Access Compliance Report

Public Rights-of-Way

(Curb Ramps)

Intersection ID: N/A	Main Street: ELLIOTT_ST	Cross Street: N_I-77_EXIT_10A_RA	Location: NW
ADA ID: BEA38126DEE9	Ramp Type: Combination2	Initial Pass/Fail: Pass	Overall Compliance: No
		Severity Score: 0.25

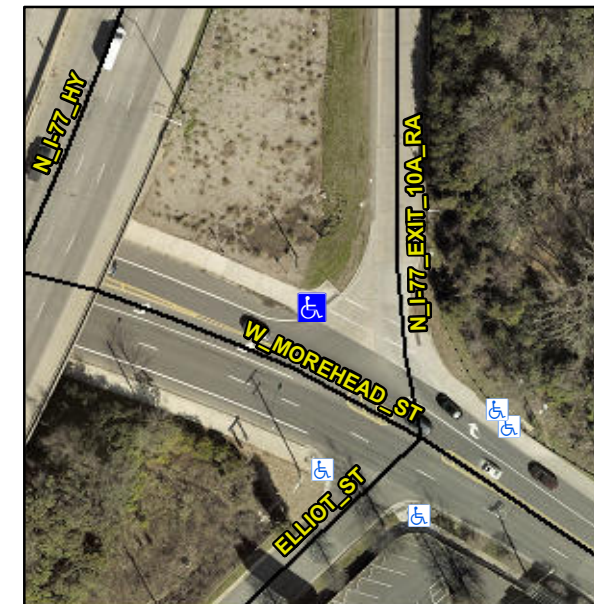
LT RP < 5%

R304.5.3, R304.2.1, R305.2

**Remove & Replace Entire Ramp.
Remove & Replace Sidewalk.**
